35-TYPE TEST SETS

1.001 This addendum supplements Section A702.002, Issue 4.

Fig. 13 – "F/V" (Fuse Voltage) Application Using No. 35D or No. 35F Test Set with Fuse or Test Link Removed from Circuit Under Test

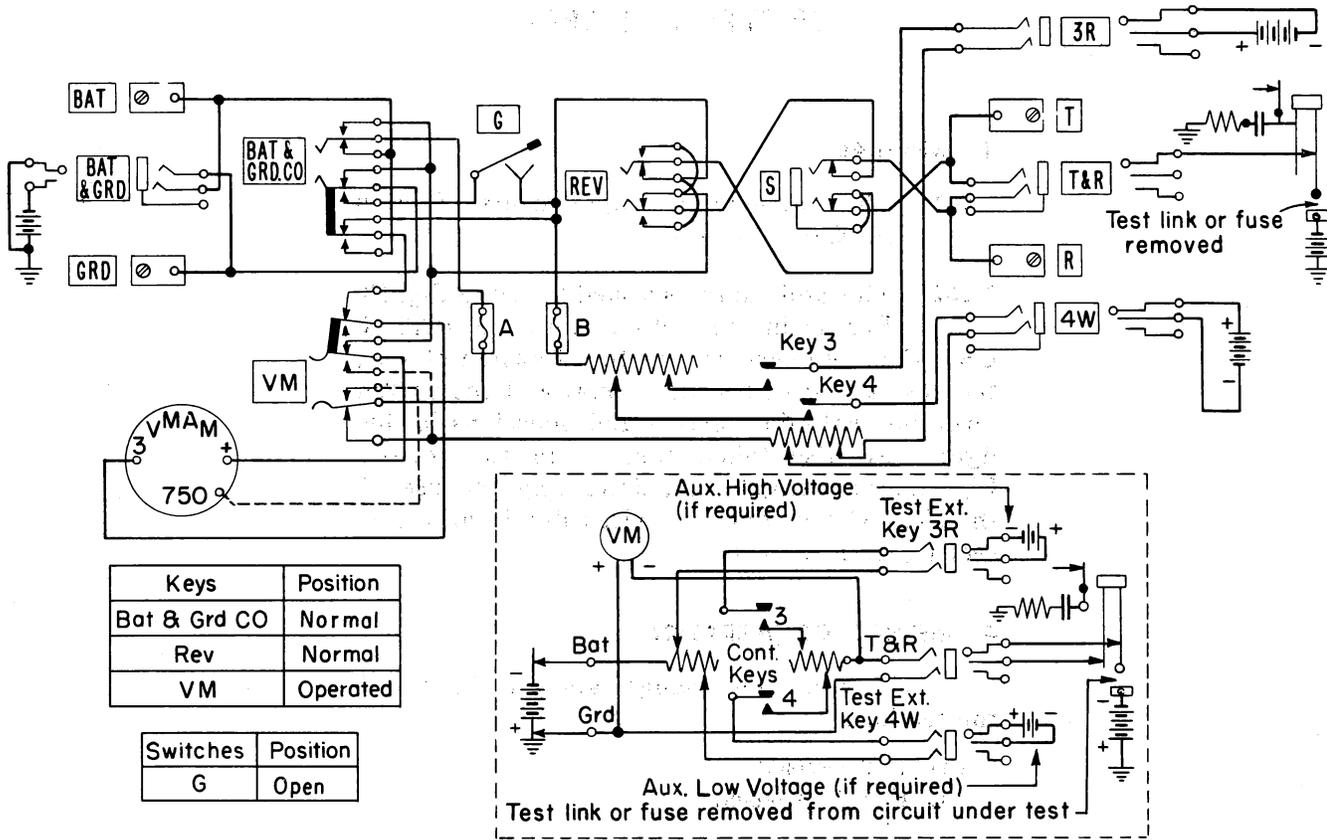
1.002 This addendum is issued to revise Fig. 13. Fig. 13 in the section shows the BAT & GRD CO key operated and the G switch closed; the key should be shown normal and the switch open. Several minor errors and omissions in this figure are also taken care of in the revised Fig. 13. Paragraph 4.09, describing the use of the No. 360-type tool, is revised due to an incorrect figure reference.

- (a) 4.09 revised
- (b) Fig. 13 revised

Keys	Position
Bat & Grd CO	Normal
Rev	Normal
VM	Operated

Switches	Position
G	Open
